## **Access Compliance Report Public Rights-of-Way** (Curb Ramps)

Intersection ID: 10033749 Main Street: OVERLOOK MOUNTAIN DR Cross Street: N/A Location: NW **Overall Compliance: No Severity Score:** ADA ID: 413DA5450D54 Ramp Type: BlendTrans1 Initial Pass/Fail: Fail 12.5

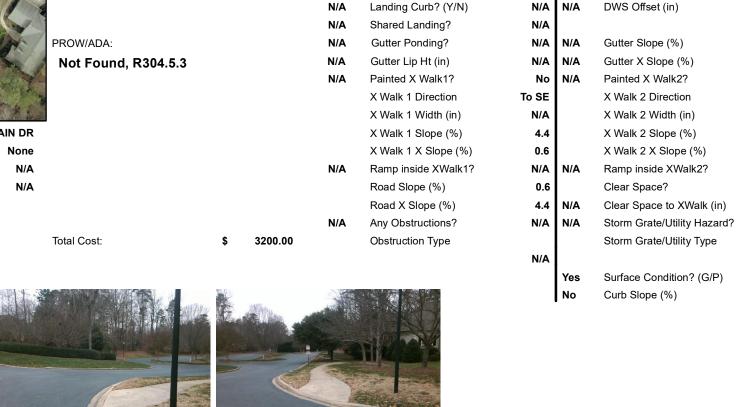
Remove & Replace Curb Ramp With Two New Directional Ramps or Equivalent.
